Belt tensioner

for
Mercedes Benz CDI engines
ref. no. 611 200 04 70

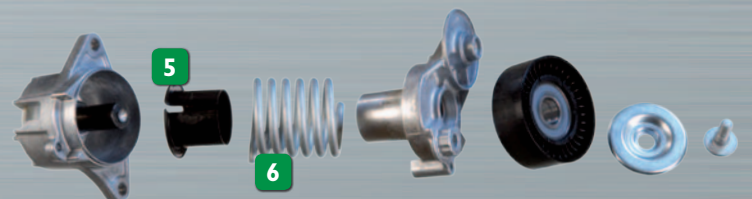
For design reasons, when the vehicle is driven with the original version of the belt tensioner installed (ref. no. 611 200 04 70), noise may occur. (The manufacturer has now replaced this version.)

The noise is generated because the spring is too long and makes direct contact with the base of the housing (1). Only the spring's torsional characteristics are important for this application (2), (6).

The noise is caused when the spring touches the cast-in hollow pin (3) and the base of the housing (4).

A highly wear-resistant plastic bushing (5) distance the spring from the base of the housing and prevents metal-to-metal contact where the spring is located. Since only the springs's torsional characteristics are important the height has been reduced (6).

The spring makes contact with the plastic bushing (7) and is therefore prevented from touching the base of the housing. No noise can therefore occur. In the new version (8), a steel pin has been cast in the base of the housing in order to center the spring.
